Product / Process Change Notification (PCN)

PCN #: PCN_UtRJ4510G_20220425

Affected Series: WE-UtRJ4510G; 7499611420; S17100112

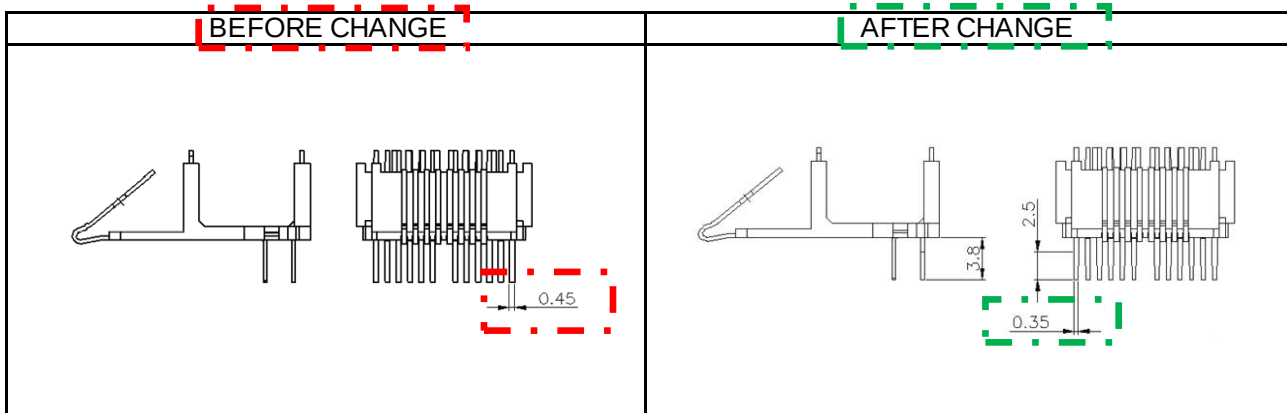
Due to an improvement of the production capability, Würth Elektronik will change the pin shape.

All products with date code 2022-04-25 or later, will be affected by this change.

There will be no change in fit, function, quality or reliability of the product.

The recommended land pattern will not change.
